Technical Service Bulletin

20505,C835

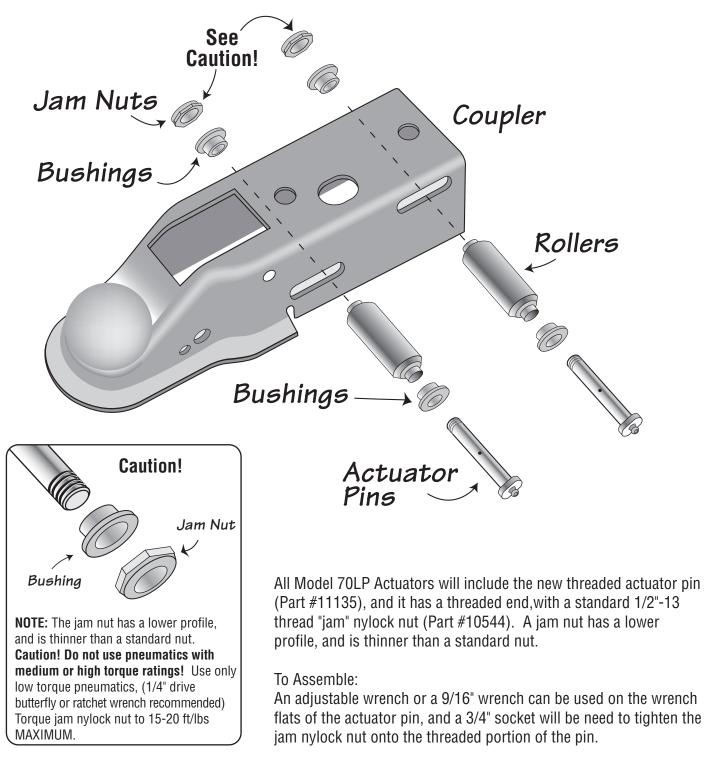
Model 70LP Actuator's required the use of a e-clip/retaining ring, to retain the actuator pin to the bushings, and actuator rollers. We are no longer using the 48795 actuator pin.
